# 77-83 Sutton Street, North Melbourne

## Road Safety Audit

11 September 2024

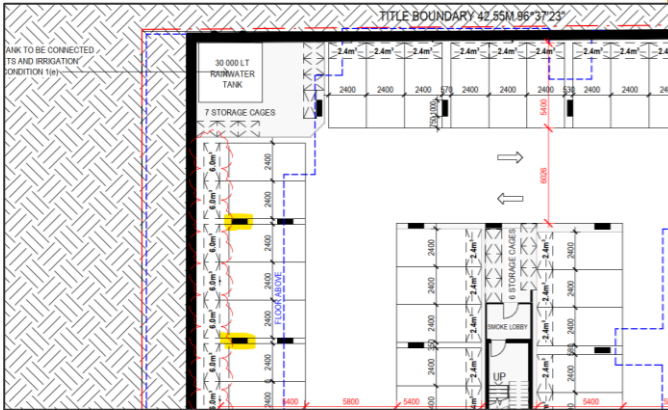
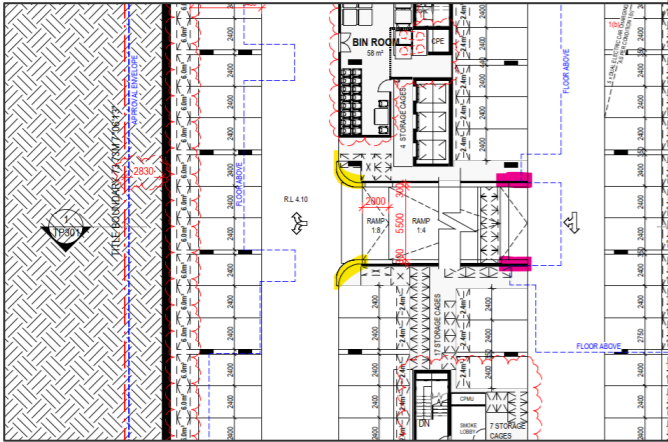
<p>2. Radii are provided at the bottom of ramps between levels, but not at the top (yellow highlight vs pink highlight below). This could affect the ability to accommodate passing movements at the top of the ramp. Additionally sightlines may be affected by the wall either side of the ramp.</p> 	<p>Confirm by means of a swept path assessment to confirm that circulating vehicle movements can be suitably accommodated. (P)</p> <p>Review sightlines at this location and adjust wall if needed and if possible to improve sightlines. (P)</p> <p>If the walls cannot be adjusted, supplementary convex mirrors should be provided to assist with sightlines. (S)</p>	<p>Rare Insignificant <b>Negligible</b></p>	<p>Within Tolerable</p>	<p>Radii have not been provided however ramp has been increased from 5.5 m to 6.7 m. Swept paths should be checked to ensure appropriate design vehicle movements can be accommodated.</p> <p>Convex mirrors are not shown at all intersections. Review sightlines and add convex mirrors if necessary.</p>	<p><b>This copied document to be made available for the sole purpose of enabling its consideration and review as part of a planning process under the Planning and Environment Act 1987. The document must not be used for any purpose which may breach any copyright</b></p>

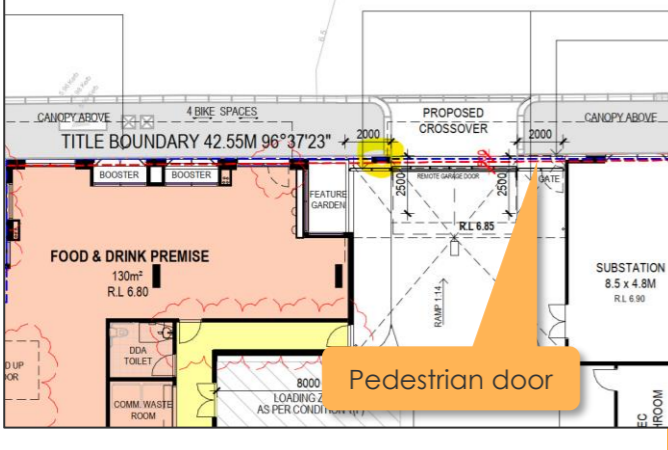
Audit Findings	Recommendations (P) Primary (ST) Step Towards (S) Supporting (N) Non Safe-System	Level of Risk	Safe System Energy	Revised / Updated Audit Finding Based on Review of P10 Plans	Designer/Project Manager Response
<p>3. Vehicles are unlikely to be able to pass at the corners and intersections within the basement levels, creating opportunities for side swiping.</p>	<p>Install convex mirrors to assist with driver sightlines. (S)</p>	<p>Rare Insignificant <b>Negligible</b></p>	<p>Within Tolerable</p>	<p>Convex mirrors have been added in some locations but not others.</p> <p>Check swept paths and add convex mirrors at all locations where concurrent passing movements are not possible and sightlines to oncoming vehicles may be compromised.</p>	
<p>4. The pedestrian sight triangle on the western side of the access driveway is compromised by the column within the prescribed area. It is acknowledged that the Planning Scheme requirement is for the prescribed area to be 'at least 50% clear of obstructions', which is technically achieved by the proposed solution, it is considered that the 50% requirement is to allow for treatments such as paling fences which wouldn't completely obscure the view to a pedestrian.</p> <p>It is acknowledged that a convex mirror is provided to assist with sightlines, however that should be considered a supplementary treatment if it is not possible to remove the issue entirely. The convex mirror appears to be installed behind the pedestrian entry door and will therefore need to be installed at a height that doesn't obstruct access. This will likely not be visible to drivers exiting the site.</p> 	<p>Review options to reduce obstructions within the pedestrian sight triangle on the western side of the driveway. This could include a column immediately to the east of the driveway (noting that the Planning Scheme acknowledges that a sight triangle on the entry side of an access is less important. (P)</p> <p>Review the positioning of the convex mirror to ensure that it can function suitably (ST)</p>	<p>Rare Minor <b>Negligible</b></p>	<p>Within Tolerable</p>	<p>Finding still applicable to revised plans.</p>	<div style="border: 1px solid red; padding: 10px; text-align: center;"> <p><b>This copied document to be made available for the sole purpose of enabling its consideration and review as part of a planning process under the Planning and Environment Act 1987. The document must not be used for any purpose which may breach any copyright</b></p> </div>

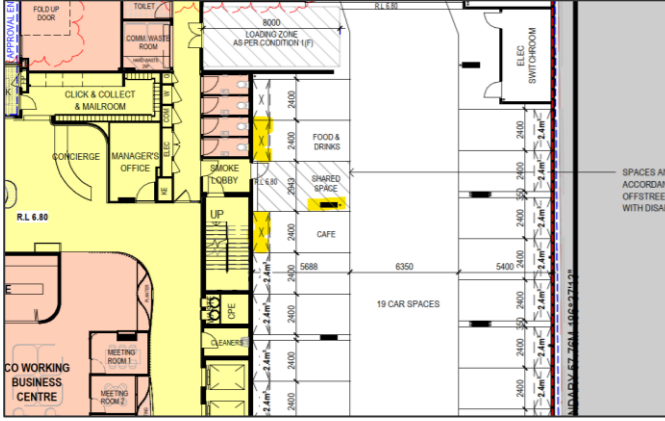
Audit Findings	Recommendations (P) Primary (ST) Step Towards (S) Supporting (N) Non Safe-System	Level of Risk	Safe System Energy	Revised / Updated Audit Finding Based on Review of P10 Plans	Designer/Project Manager Response
<p>5. The spaces for the café and food and drink premises feature a shared area between them, so that they could be used by people with disabilities, should they have the need to.</p> <p>While not necessarily a safety concern, there it is suggested that storage cages over the end of these spaces could make them more difficult to use for people with disabilities. Additionally while Australian Standard 2890.6:2022 does allow for a column to be located within the shared area, the column shown on the plans does not fall within the area permitted under the standard.</p> 	<p>Consider the design of these spaces with regard to the requirements of AS 2890.6:2022. (N)</p>	<p>Note</p>	<p>Not Applicable</p>	<p>Storage cages no longer provided in these spaces.</p> <p>Column is still located within the shared area and should be addressed.</p>	<div style="border: 2px solid red; padding: 10px; text-align: center; color: red;"> <p><b>This copied document to be made available for the sole purpose of enabling its consideration and review as part of a planning process under the Planning and Environment Act 1987. The document must not be used for any purpose which may breach any copyright</b></p> </div>
